**Snap Lake Environmental Monitoring Agency**  
**Main Floor, Lahm Ridge Tower**  
**4501 Franklin Avenue**  
**P.O. Box 95, Yellowknife, NT X1A 2N1**  
**Phone: 867-765-0961 FAX: 867-765-0963**  
**Website: [www.slema.ca](http://www.slema.ca)**

File: Water Licence Annual Report (WLAR)

Comments – 2006 WLAR  
Author – Zhong Liu  
Date – July 26, 2007

### Water Level vs. Project Development

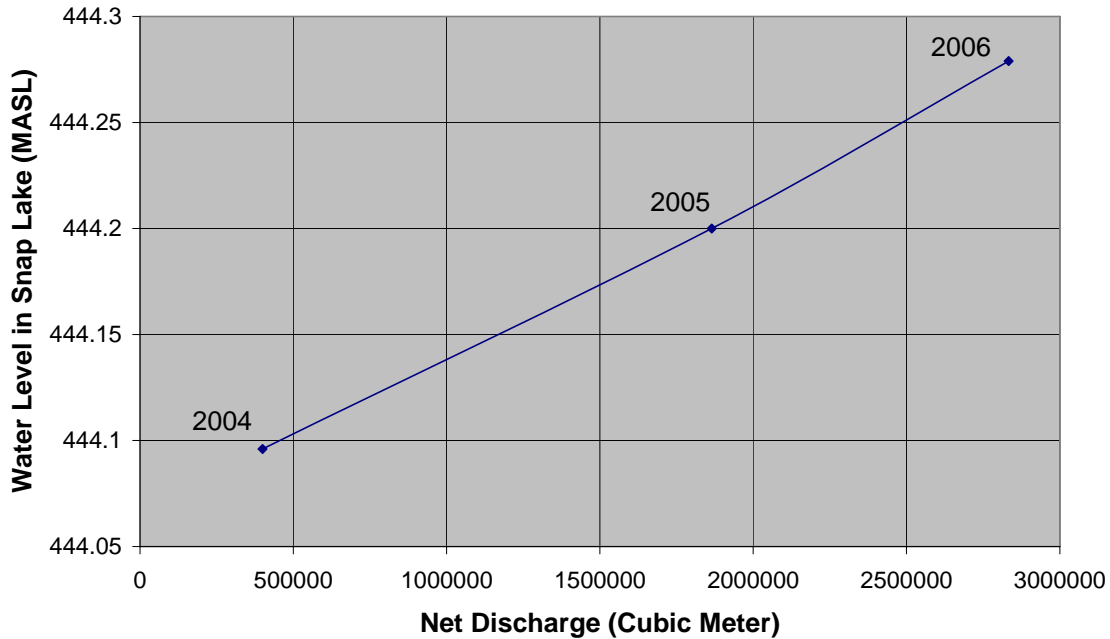
- Section 11 (Part B, Item 5b), p17: It is noticed that the seasonal mean elevation of water in Snap Lake during the ice-free conditions increased from 444.096 meters above sea level (MASL) in 2004, to 444.200 MASL in 2005, then to 444.279 MASL in 2006. Is it a natural trend or related to the Project development? The following chart indicates an association between the net discharge (discharge from Water Treatment Plant and Sewage Treatment Plants minus water intake) and the water level in Snap Lake. Further investigation is recommended.
